**AGENDA
MAPLE PLAIN CITY COUNCIL – SPECIAL MEETING
MAPLE PLAIN CITY HALL
JULY 16, 2018
5:30 P.M.**

Request by Elim Care, Inc./Augustana Care for Site Plan Review, Preliminary Plat and Final Plat to Allow a Mult-Family Senior Housing Development on the Property Located at 1425 Baker Park Road

<i>To:</i>	City Council
<i>From:</i>	Mark Kaltsas, City Planner
<i>Meeting Date:</i>	July 16, 2018
<i>Applicant:</i>	Elim Care, Inc./Augustana Care
<i>Owner:</i>	Maple Plain Gateway Prop., LLC
<i>Location:</i>	1425 Baker Park Road

To:	Mark Kaltsas	From:	Dan D. Boyum
	City Planner		City Engineer
File:	193804259	Date:	July 10, 2018

SHEET NAME
**PRELIMINARY
OVERALL
LANDSCAPE PLAN**

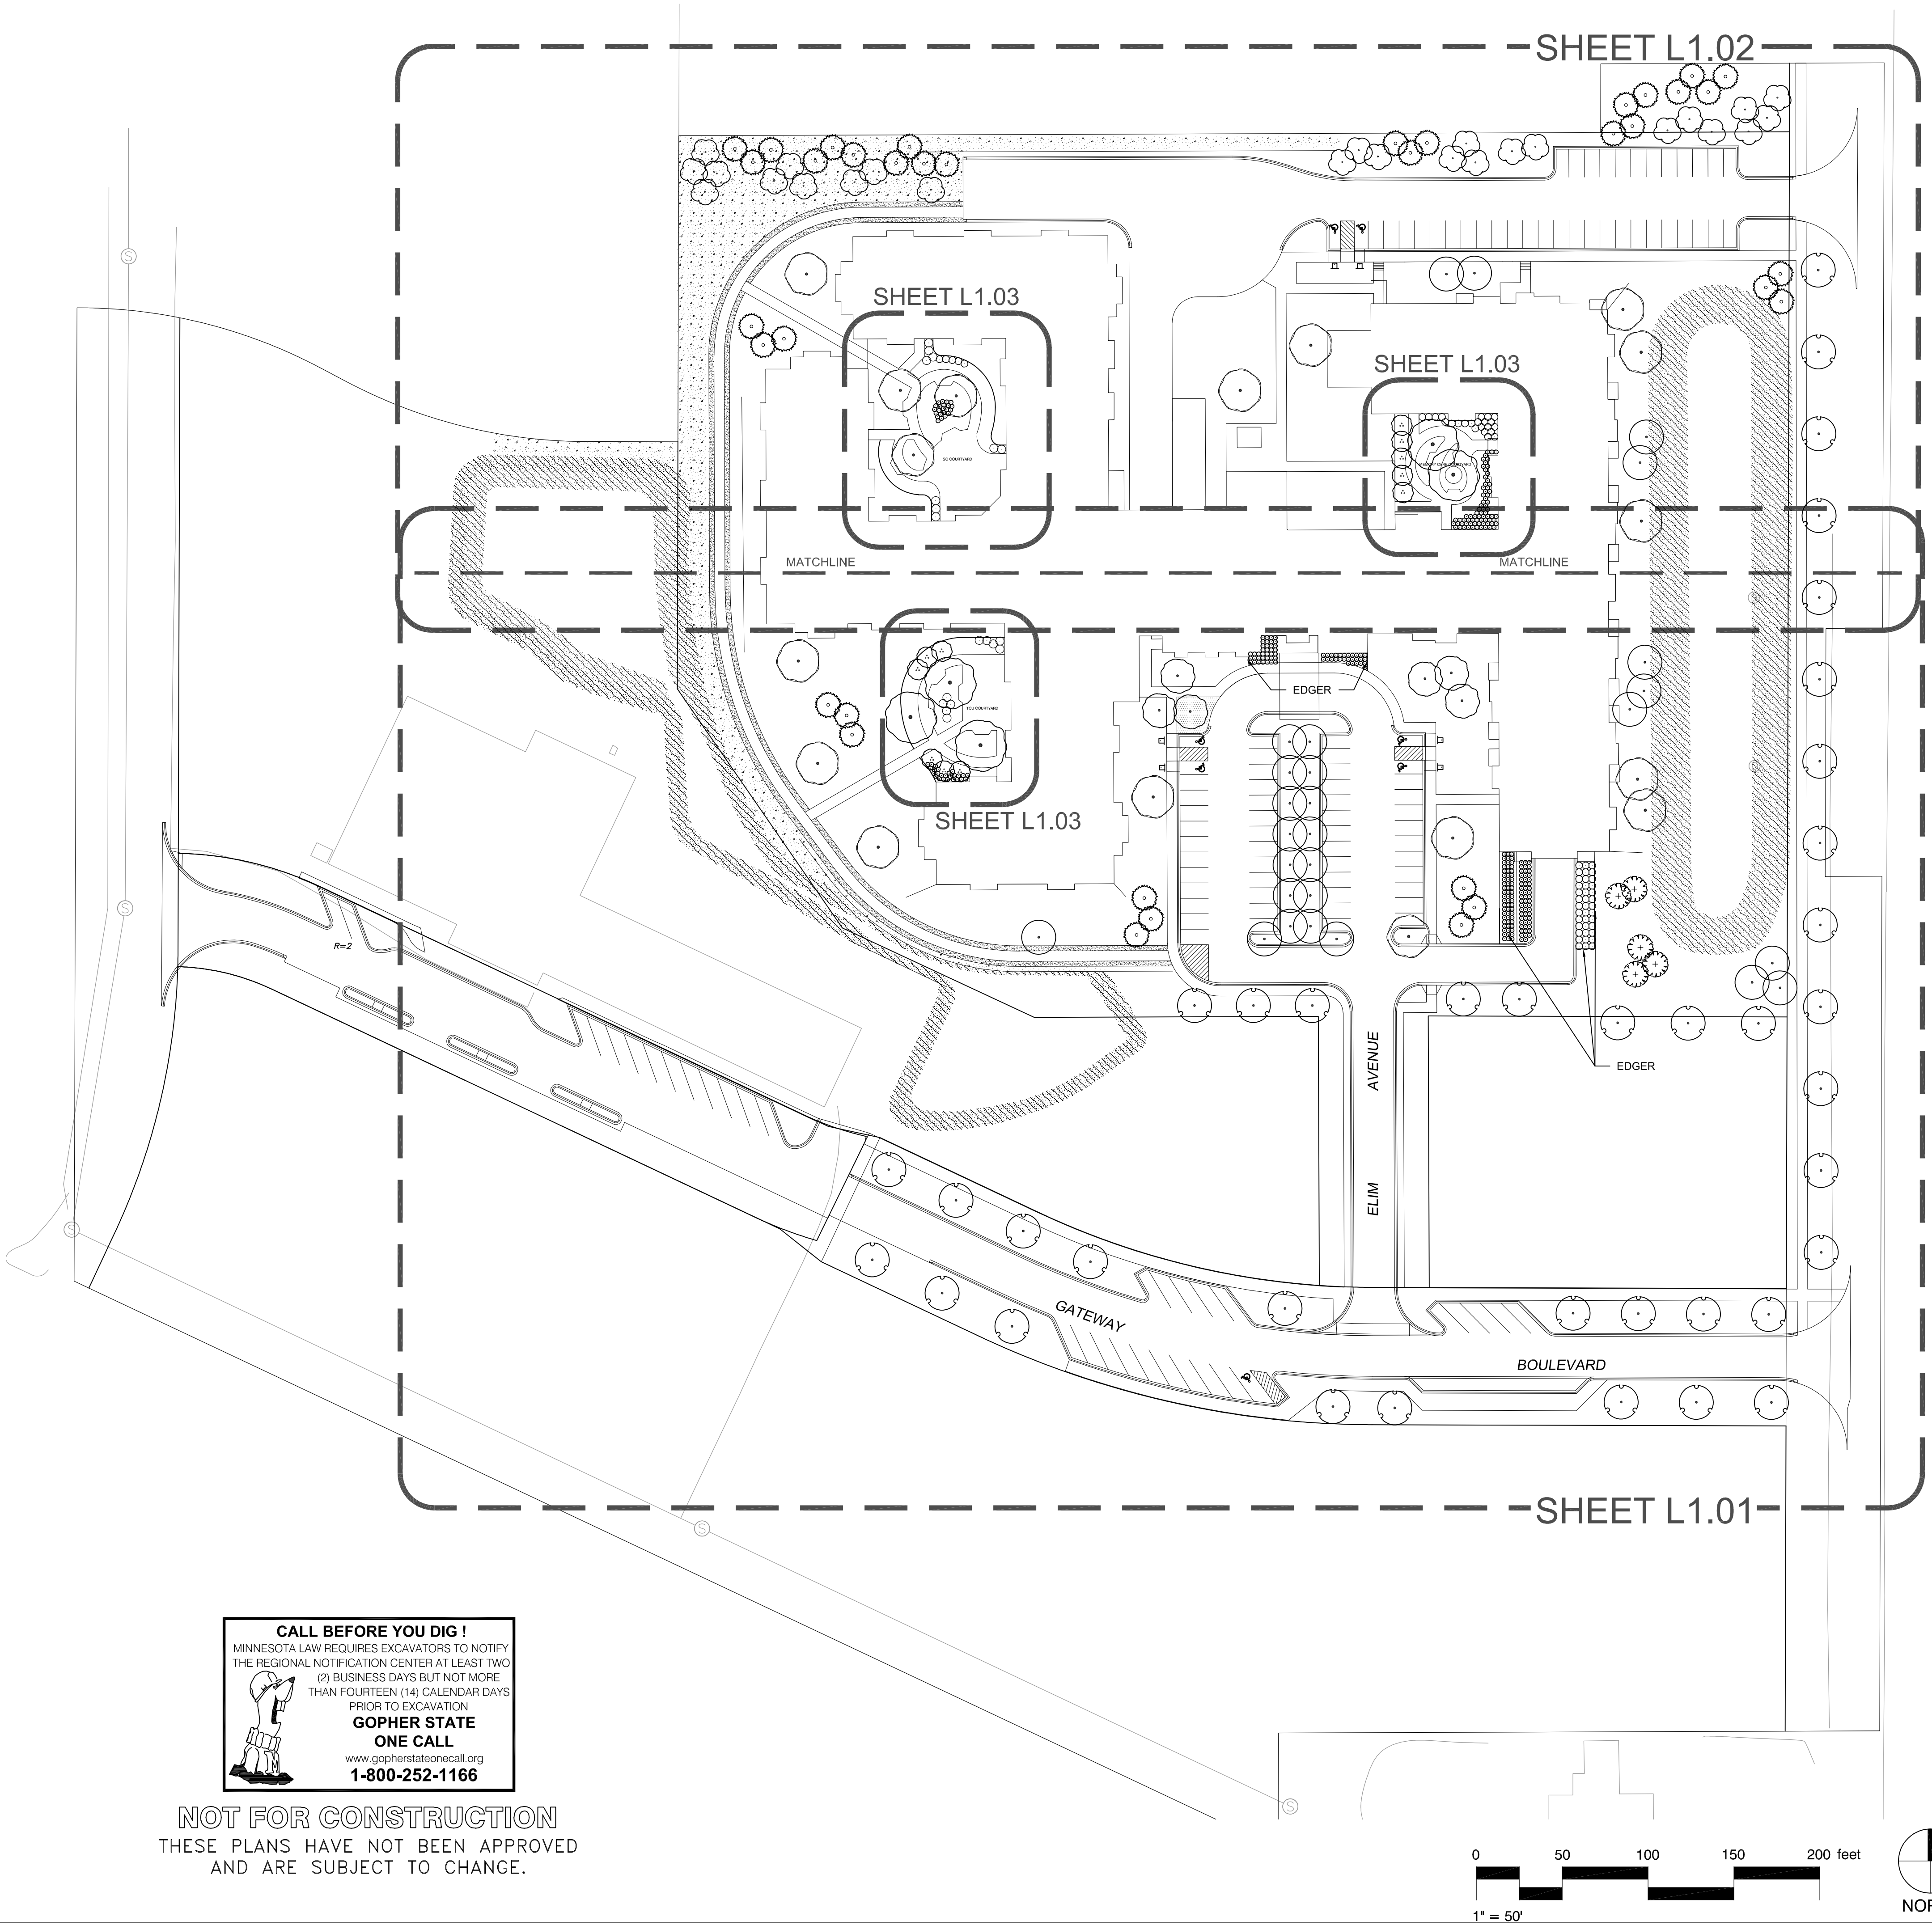
Overall Landscape Plan (Sheets L1.00 to L1.02)
